E8801A-01C**S E R V I C E****N O T E**Supersedes:
E8801A-01B**E8801A PNA Series RF Network Analyzers**

Serial Numbers: 00000000 thru 46999999

July 26, 2007

Figure 1

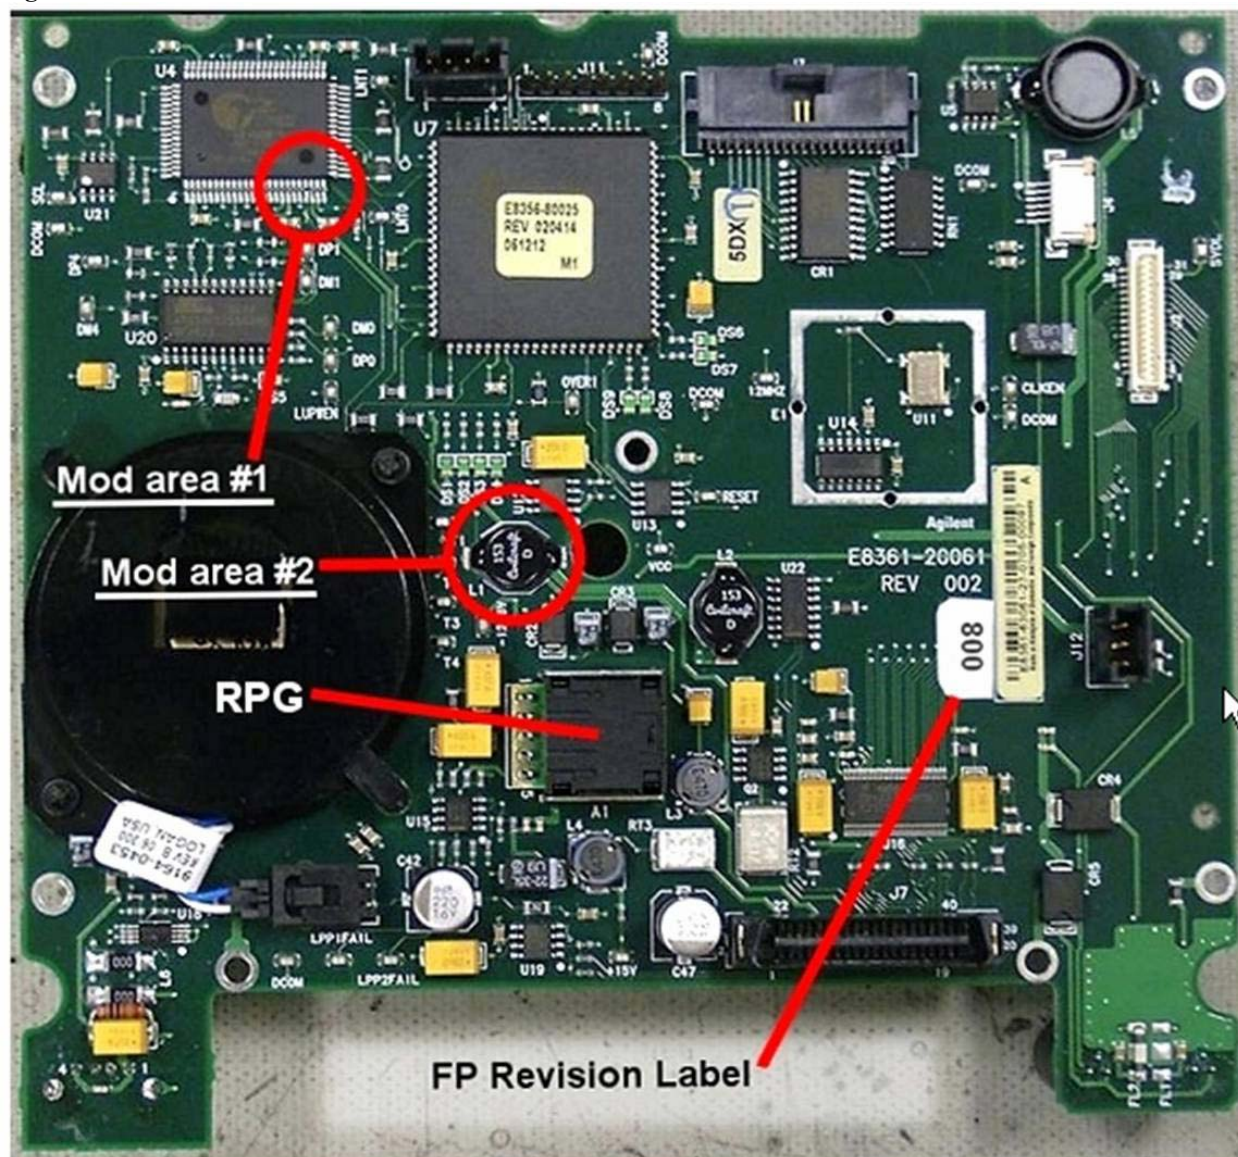
Refer to Figure 1 for the two modification areas to be addressed. Note that while this picture happens to show the FPI board completely removed from the front frame assembly, this is not necessary to perform the required modifications.

- Modification #1 consists of shorting two pins of U4 together with a small amount of solder.
- Modification #2 consist of removing L1.

Unsolder and completely remove the black surface mount inductor L1 from the front panel assembly board. This is no longer needed and can be discarded.

Figure 2

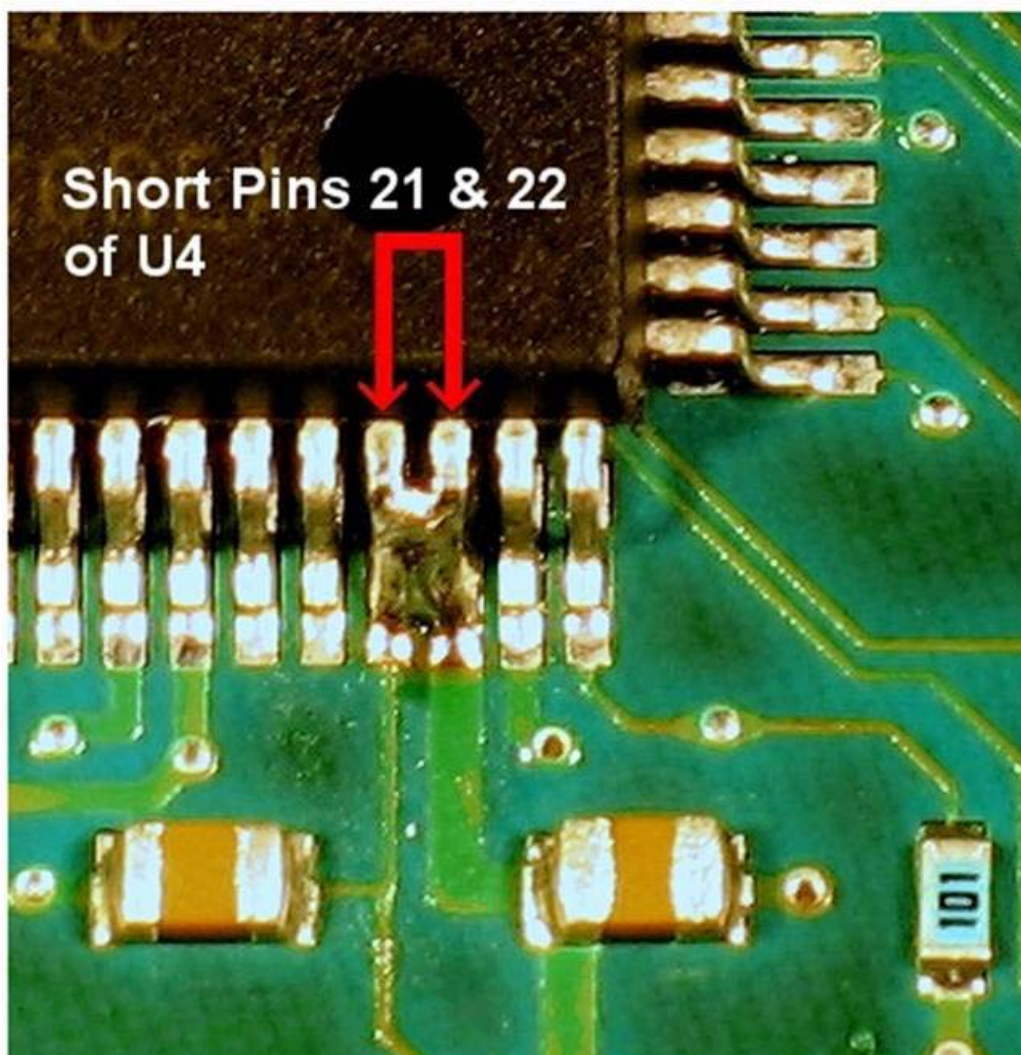
Carefully solder pins 21 and 22 together on U4. Refer to Figure 2 for the exact location. Use care so that no other pins are shorted. Use of a very fine tip soldering iron is recommended and a large work-task magnifying glass is very helpful.
